# Access Compliance Report

## Public Rights-of-Way

Intersection ID: 5507	Main Street: GIBBON_RD	Cross Street: HORACE_MANN_RD	Location: S
ADA ID: 091C6339B173	Ramp Type: Perp	Initial Pass/Fail: Fail	Overall Compliance: No
		Severity Score: 8.75

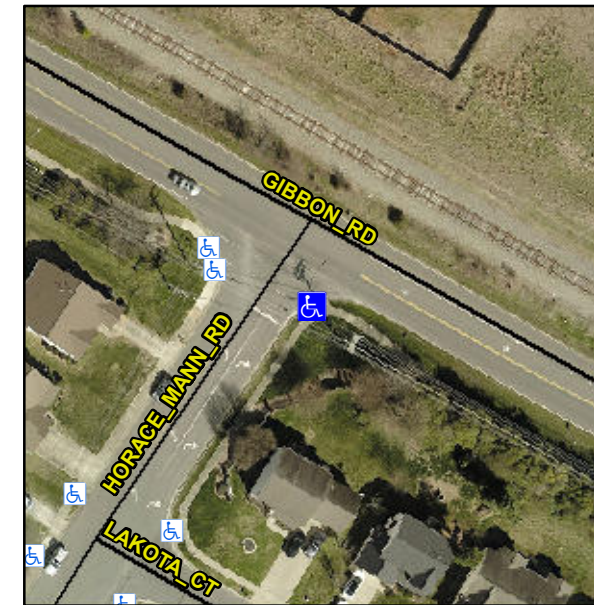
**R304.5.1**

Compliance	Description	Data	Compliance	Description	Data
N/A	Ramp Length (in)	49.0	Yes	Ramp Slope (%)	5.2
No	Ramp Width (in)	37.5	Yes	Ramp XSlope (%)	0.4
N/A	Flare Type LT	N/A	N/A	Flare Type RT	N/A
N/A	Flare Slope LT (%)	N/A	N/A	Flare Slope RT (%)	N/A
N/A	Flare Traversable LT?	N/A	N/A	Flare Traversable RT?	N/A
N/A	Landing Length (in)	N/A	N/A	DWS Provided?	N/A
N/A	Landing Width (in)	N/A	N/A	DWS Contrast?	N/A
N/A	Landing Slope (%)	N/A	N/A	DWS Length (in)	N/A
N/A	Landing X Slope (%)	N/A	N/A	DWS Full Width?	N/A
N/A	Landing Curb? (Y/N)	N/A	N/A	DWS Offset (in)	N/A
N/A	Shared Landing?	N/A			
N/A	Gutter Ponding?	N/A	N/A	Gutter Slope (%)	N/A
N/A	Gutter Lip Ht (in)	N/A	N/A	Gutter X Slope (%)	N/A
N/A	Painted X Walk1?	Yes	N/A	Painted X Walk2?	N/A
	X Walk 1 Direction	To NW		X Walk 2 Direction	N/A
N/A	X Walk 1 Width (in)	111.0	N/A	X Walk 2 Width (in)	N/A
	X Walk 1 Slope (%)	1.4		X Walk 2 Slope (%)	N/A
	X Walk 1 X Slope (%)	2.9		X Walk 2 X Slope (%)	N/A

N/A	Ramp inside XWalk1?	Yes	N/A	Ramp inside XWalk2?	N/A
	Road Slope (%)	N/A	N/A	Clear Space?	N/A
	Road X Slope (%)	N/A	N/A	Clear Space to XWalk (in)	N/A
N/A	Any Obstructions?	N/A	N/A	Storm Grate/Utility Hazard?	N/A
	Obstruction Type			Storm Grate/Utility Type	
		N/A			N/A
			Yes	Surface Condition? (G/P)	Good

**Remove & Replace Entire Ramp.**
